WILLIAMSON COUNTY, TEXAS

CHANGE ORDER NUMBER: 14

**FM3349 at US 79
Williamson County Project No. 22IFB139**

Change Order No. 14

INTERIOR DRAINAGE
CULVERT LAYOUT
B-SB-CV-01

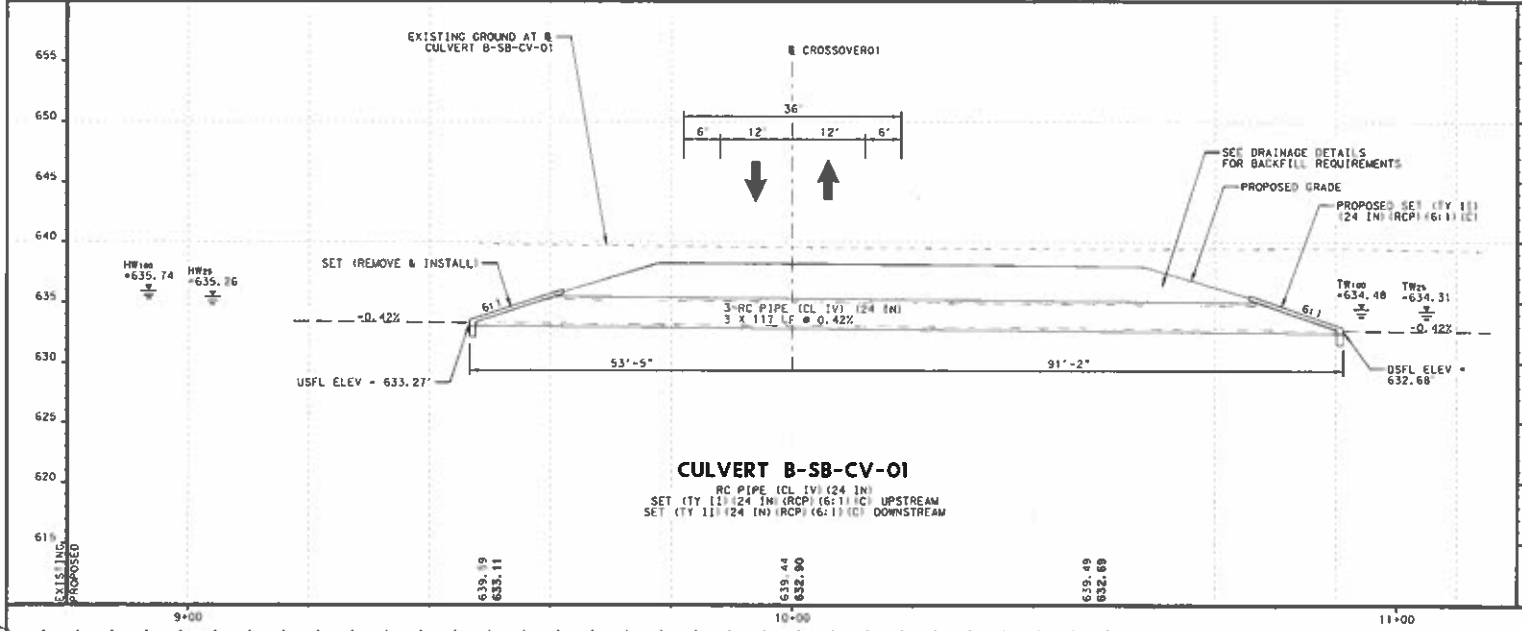
2C . New Development (Conditions Changing After PS&E Completed). This Change Order provides compensation to the Contractor for relocating box culvert No. 4 on the southbound frontage road, to accommodate the location of the new City of Hutto street (Spine Road). The culvert and crossover to FM 3349 were moved approximately 36 ft. to the north to align with the centerline of the Spine Road.
